Subject: NEW DIFFERENTIALS DO NOT COME WITH BREATHER CAPS	Service Alert No.: SA-009/22
	Last Issued : 02/18/2022

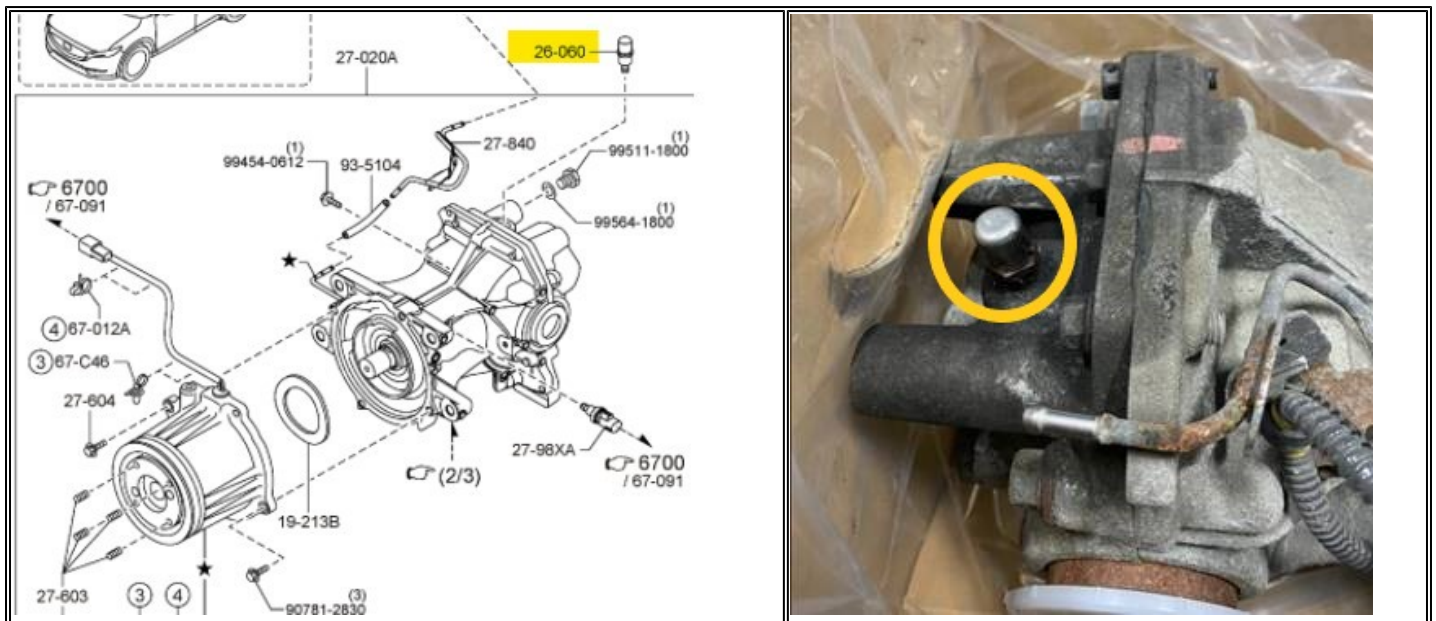
The new AWD rear differential DOES NOT come with a breather cap on the rear of the differential, therefore a new one will need to be ordered and installed when replacing the differential.

- The breather threads have a sealant and locking compound that prevents it from being reused.
- Refer to GEPC for the correct part number of the Differential Breather.
- The instructions on MGSS will be updated soon to include replacing the breather when replacing the differential with a new unit.
